Parts Manual

Series 90

55cc Axial Piston Pump

Servo arm change

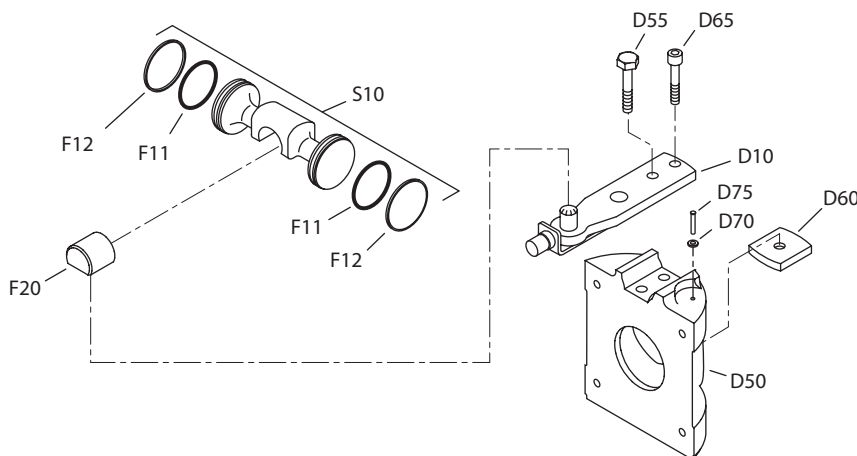
As a product improvement, Sauer-Danfoss has changed the series 90 pump servo arm and swashplate (item D10 and D50). The old style servo arm and swashplate will become obsolete. Because this change creates non-interchangeability between new and old swashplates, servo arms, and possibly servo piston (item S10) and slider block (item F20), separate servo arms and swashplates will no longer be sold as service parts.

Also, the new servo arm is actually a press fit into a groove in the new swashplate. This situation requires special tooling for assembly, therefore, pre-assembled kits will be created for 55, 75, and 100 cc pumps. The kits will work in any vintage pump.

The kit for 55 cc pumps will include all the items in the figure, except item S10

The kit for 75 cc pumps will include all item in the figure.

The kit for 100 cc pumps will include all items in the figure, except items S10 and F20.

Change goes into effect with s/n 88-14-xxxxx on 55 cc pumps and with s/n 88-16-xxxxx for 75 cc and 100 cc pumps.

Change to fixed clearance slipper hold down

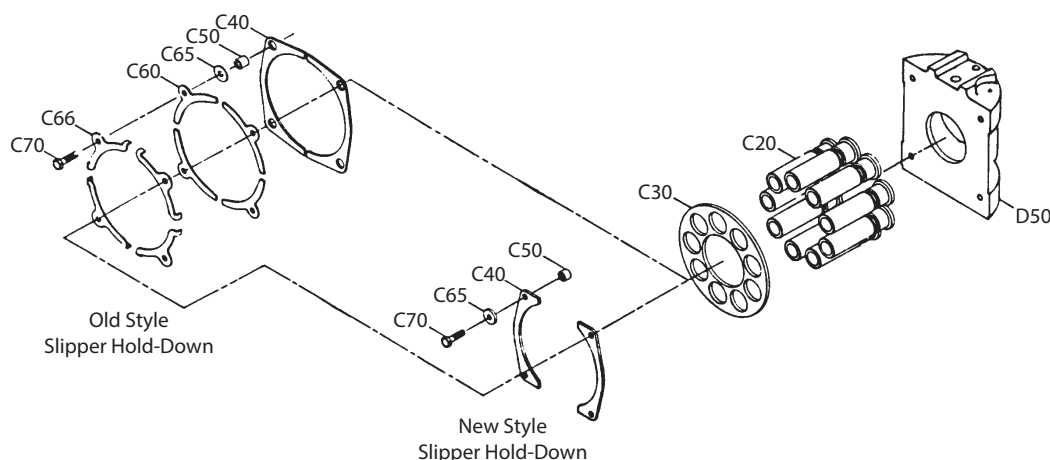
As a product improvement, Sauer-Danfoss has simplified the design of the series 90 pump slipper hold down mechanism. The hold down changes from spring loaded with a fixed maximum clearance design.

The leaf spring (item C60) and spring aligner (item C66) will be eliminated and will not be available as service parts.

The spacer (item C50), bearing (item C40), and washer (item C65) will change and the old part numbers will not be available as service parts.

Service Bulletin: SB-1988-024

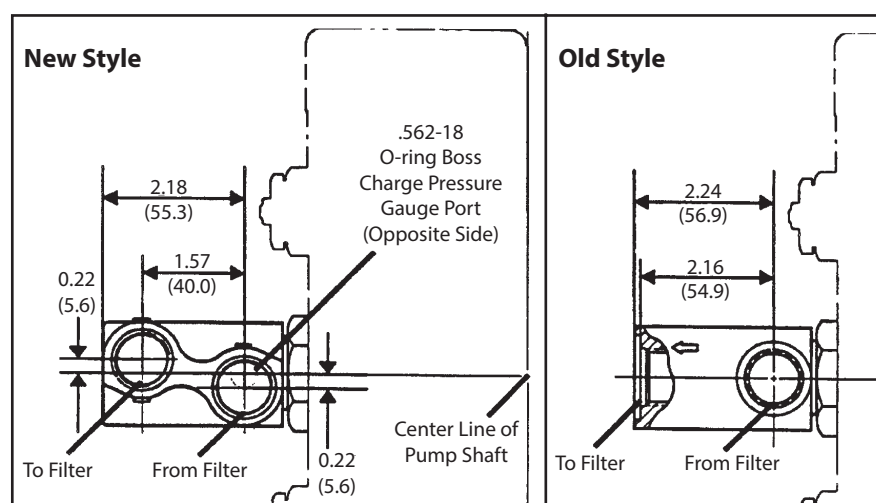
Subject Remote pressure filtration adapter change

Description The configuration of the remote pressure filtration adapter, available as an option on Sauer-Danfoss series 90 variable pumps (55, 75, and 100 cc) is changing. This improved design adapter incorporates a charge pressure test port. In addition, the remote filter connections have been relocated to improve the customer interface and the routing for filter plumbing on most applications. Port sizes did not change. (A version of the improved design adapter is already being used on Series 90 42 cc variable pumps.)

This change does not affect the pump end cap, and either design filtration adapter can be used on any vintage pump. Only the new style adapter will be available as service parts or on new production pumps.

Charge pump design change

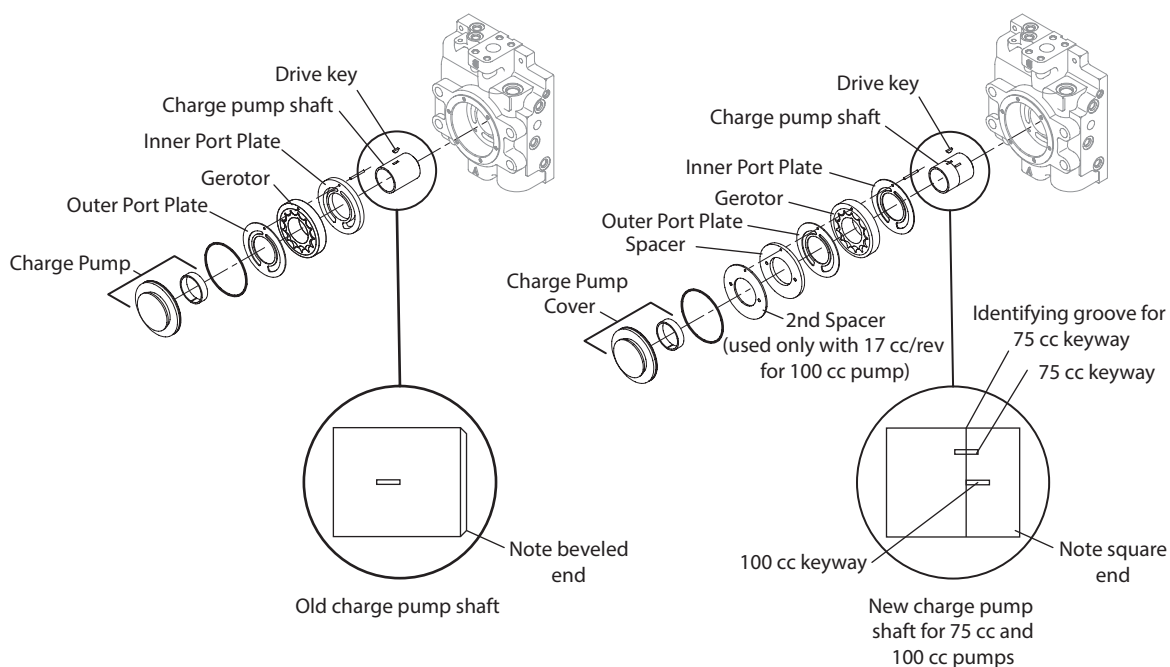
Models affected	All 94-2xxx (55 cc), 95-2xxx (75 cc), and 96-2xxx (100 cc) pumps
Serial numbers	A-89-17-xxxxx for all pumps manufactured in Ames, Iowa. N-89-07-xxxxx for al 95-2xxx (75 cc) pumps manufacture in Neumunster, West Germany. N-88-48-xxxxx for all 96-2xxx (100 cc) pumps manufacture in Neumunster, West Germany.
Part numbers affected	Proper part number versus pump serial number information can be found in the series 90 Parts Manuals. The thicker inside port plates (thicker than 0.050 in (1.27 mm) will be obsoleted and no longer available as service parts. If these parts require replacement, use the 0.050 in. 1.27 mm) port plate and appropriate spacer(s) as service parts. On 100 cc pumps only, the new charge pump shaft must be used if the new style spacer is used, On 55 and 75 cc pumps, the charge pump shaft clearance pocket in the end cap changed from a beveled to a straight corner to correspond with the change in the charge pump shaft. Old style charge pump shafts will remain available as service parts and must be used in the 55 and 75 cc beveled pocket end caps. Old style (beveled pocket) end caps will be obsoleted and no longer available as service parts. If an old style end cap needs replacement, new style end caps can be used with any vintage charge pump hardware and charge pump shaft.

Parts disposition	■ Non-interchangeable - must use correct charge pump shaft per serial number of pump

Change takes place at serial number A-89-17-xxxxx.

End cap and housing change

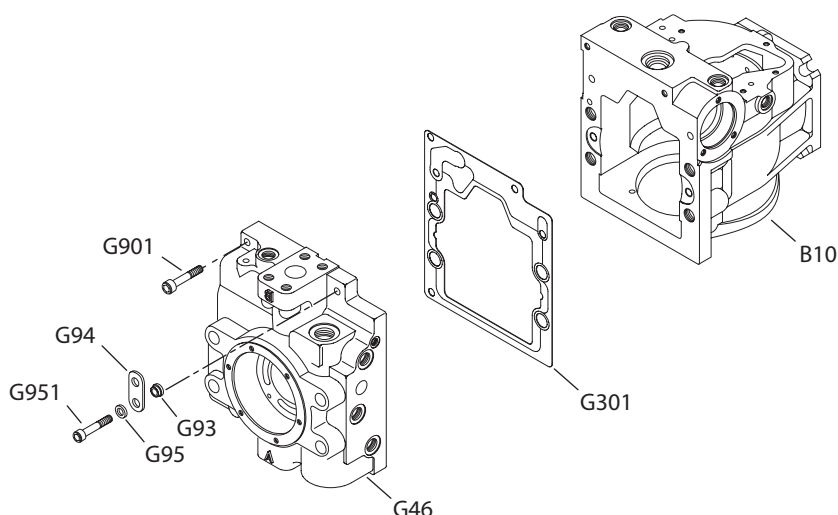
Subject Block point change: components redesign

Description As part of our overall series 90 product improvement program, numerous components are being redesigned. This redesign is referred to as a "block point" change. The objective of the block point change is to minimize the number of times we change the units while we convert to high volume tooling at various plant sites. These design improvements will provide increased reliability and more application flexibility. The nature of these changes makes customer requalification unnecessary. Old style (pre-block point) variable housings and end caps will no longer be available as spare parts.

End cap: Match housing change; small end cap screws will be larger, orientation of charge relief valve on side port end caps has been changed from oblique to vertical.

Parts disposition ■ Non-interchangeable

Change takes place at serial number A-89-47-xxxxx.

Service Bulletin: SB-1992-011

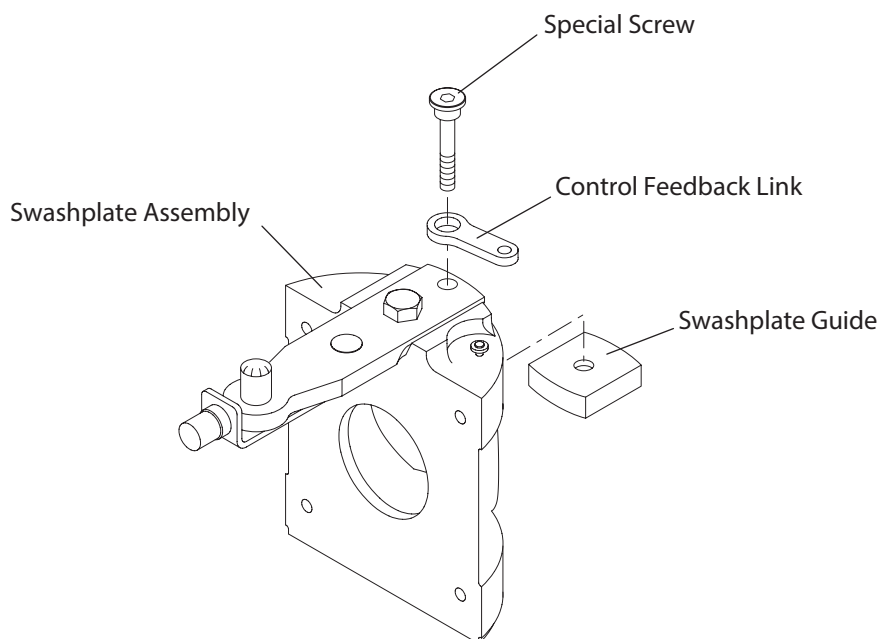
Description Effective in September of 1992, the feedback link in series 90 pumps will be mechanically retained to the swashplate. In the past, the link slipped over a specially ground socket head screw and could fall off the screw during assembly. The screw has changed to include a head to retain the link. The feedback link does not change.

Service Bulletin: SB-1994-017

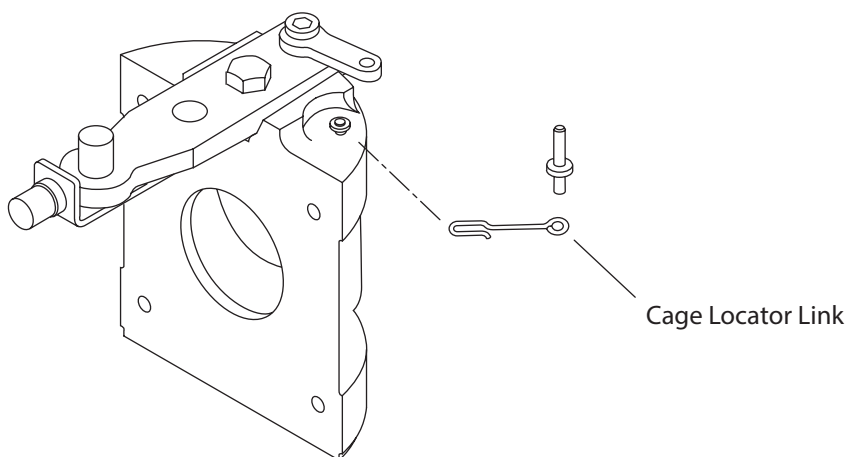
Description As a product improvement, Sauer-Danfoss has made a design change to the cage locator link used on the 55 thru 100 cc variable pumps.

The new link is made from square wire. In the past, the link was made from round wire. This is an interchangeable change.

Service Bulletin: SB-1998-018

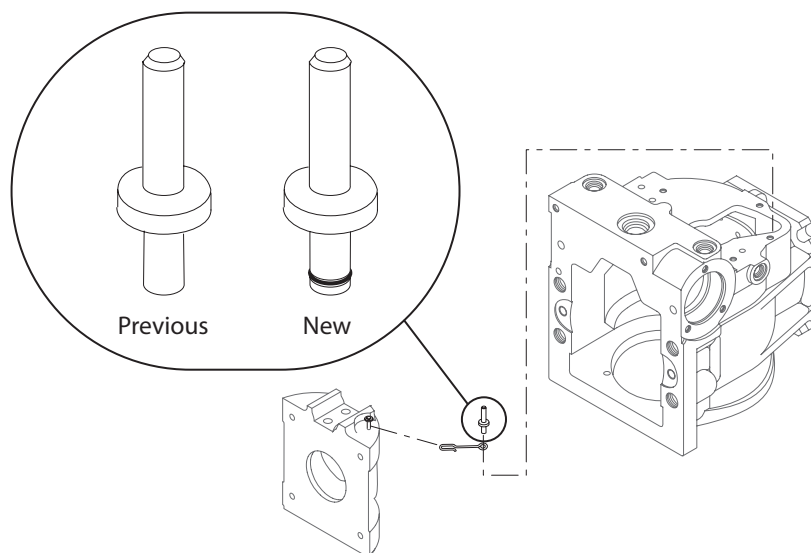
Subject Swashplate bearing cage locator pin

Description Sauer-Danfoss has modified the design of the swashplate bearing cage locator pin used in the series 90 55, 75, and 100 cc variable displacement pumps.

To aid in identifying this change, Sauer-Danfoss has released a new part number for the updated pin design. The new pin is completely interchangeable with the previous pin part number. The previous pin has been obsoleted.

Serial numbers This change became effective at serial number 98-24-xxxxx

Charge pump shaft part number change

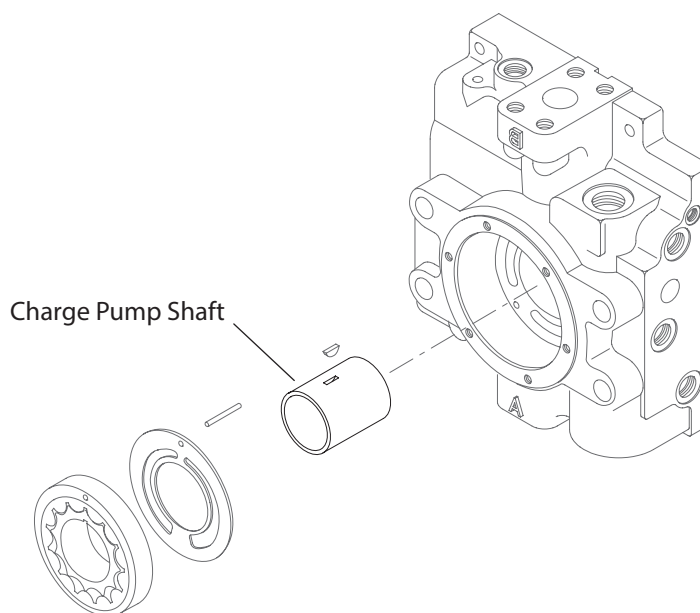
As a product improvement, Sauer-Danfoss has modified the design of the charge pump shaft used in series 90 55, 75 and 100 cc pumps. This change affects all charge pump sizes (11, 14, 17, 20, 26, and 31 cc) available in the series 90 displacement range.

The design modification includes a surface finish change to the charge pump shaft which improves the wear characteristics between the charge pump shaft and the journal bearings in the charge pump cover and end cap.

To assist in identifying this change, Sauer-Danfoss has released new charge pump shaft part numbers. The new shafts are completely interchangeable with the previous shafts. The new shaft has replaced the previous shaft in new pump assemblies and charge pump service kits. The previous shafts have been obsoleted and are no longer available as a service part. The chart on the next page will assist you in determining the part number changes.

NOTE: Pump models 9621723 and 9622117 were released with a special charge pump option (code W - 26 cc charge pump with special shaft). With this product modification, the charge pump option code for these two models has been changed from W to the standard option (code F - 266 cc charge pump). The special shaft part number 8801176 has been obsoleted and replaced with shaft part number 8801178.

Auxiliary flange charge pump cover

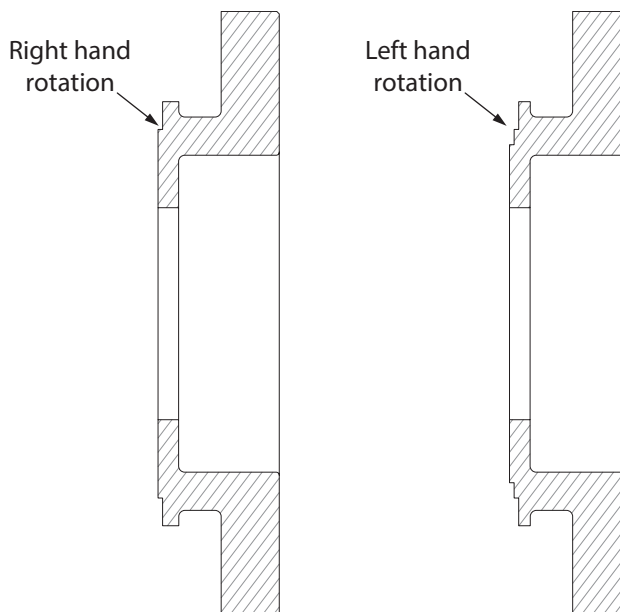
The part numbers of the charge pump covers will not change.

Also, the flanges will no longer have a slotted interface with a washer for the end cap screws. The flanges will now have round through holes for the end cap screws and will use no washers. The end cap screws do not change. This eliminates the area where water or high pressure wash chemicals can be trapped around the end cap screws. There now are specific part numbers for the flanges used on each of the three displacement size pumps; 55, 75 and 100 cc.

The pumps will now be supplied with the donut style A pad seal and new flat cover, instead of the small O-ring and cover plate (shown in the drawing below).

This change became affective at serial number; A 07-05-xxxxx.

Subject SAE C auxiliary mounting flange

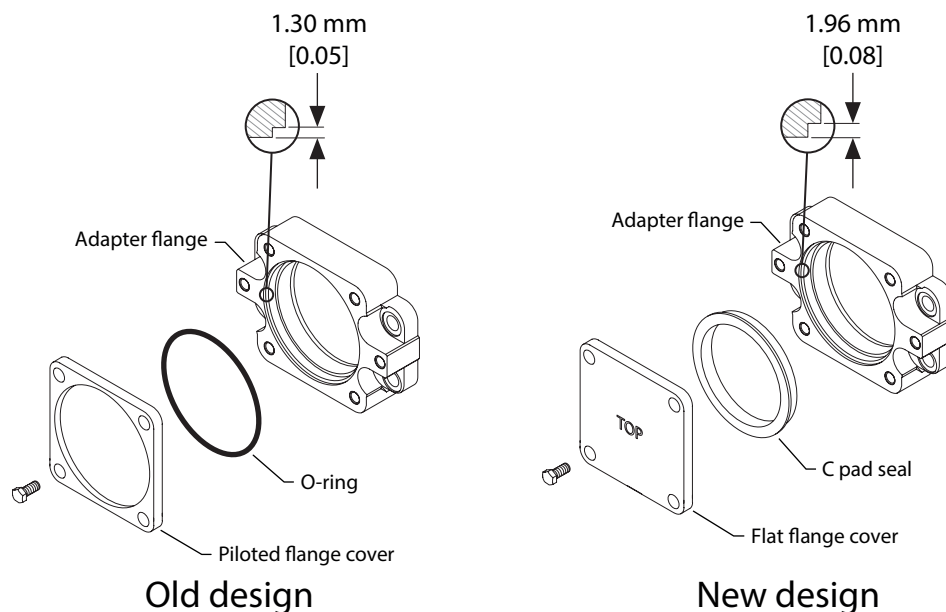
Part numbers affected Sauer-Danfoss is pleased to announce a design improvement on the SAE C auxiliary mounting flange adapter on its series 90 pumps. The frame sizes affected by this change are 55, 75, and 100cc. All manufacturing locations producing these pumps will be changed to this configuration.

The pumps will now be supplied with the donut style seal and new flat cover, instead of the small O-ring and cover plate (shown in the drawing below).

Serial numbers This change became affective at serial number; A 08-19-xxxxx and N 09-30-xxxxx.

Subject SAE B auxiliary mounting flange

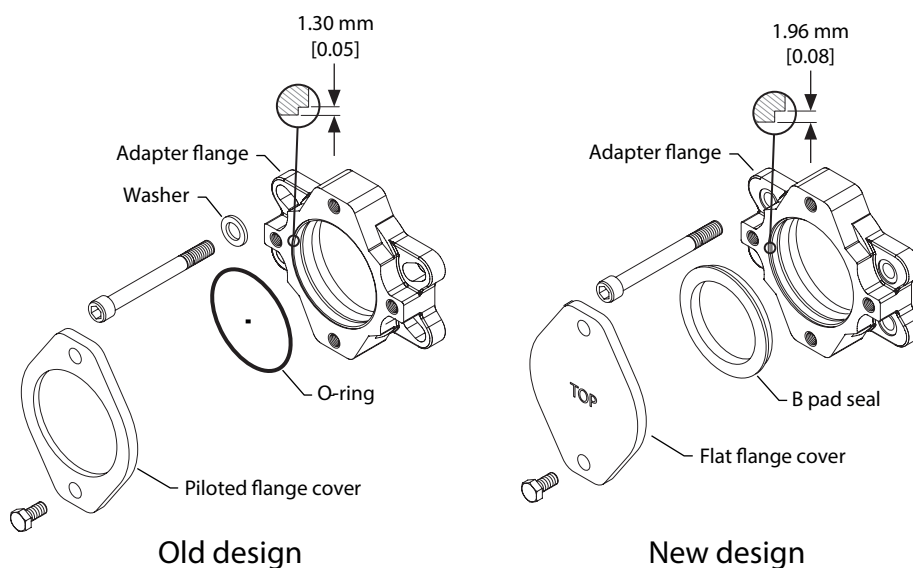
Part numbers affected Sauer-Danfoss is pleased to announce a design improvement on the SAE B auxiliary mounting flange adapter on its series 90 pumps. The frame sizes affected by this change are 55, 75, and 100cc. All manufacturing locations producing these pumps will be changed to this configuration.

The improvement comes in the form of a more robust sealing geometry with a larger cross-section O-ring. The O-ring groove in the flange will now be sized to mate with a 2.62mm [0.103] cross section O-ring rather than the old 1.78mm [0.070] cross-section O-ring. The Sauer-Danfoss part number for the new O-ring is 9004104-1540 (2.62mm [0.103] x 94.92mm [3.737]). The larger cross-section sealing geometry allows for the use of a donut style B pad seal and a new flat cover for improved assembly. This new configuration is qualified as a running cover. When installing an auxiliary pump, the donut style B pad seal must be discarded and part number 9004104-1540 O-ring used.

Also, the flanges will no longer have a slotted interface with a washer for the end cap screws. The flanges will now have round through holes for the end cap screws and will use no washers. The end cap screws do not change. This eliminates the area where water or high pressure wash chemicals can be trapped around the end cap screws. There now are specific part numbers for the flanges used on each of the three displacement size pumps; 55, 75 and 100 cc.

The pumps will now be supplied with the donut style seal and new flat cover, instead of the small O-ring and cover plate (shown in the drawing below).

Serial numbers This change became affective at serial number; A 08-19-xxxxx.
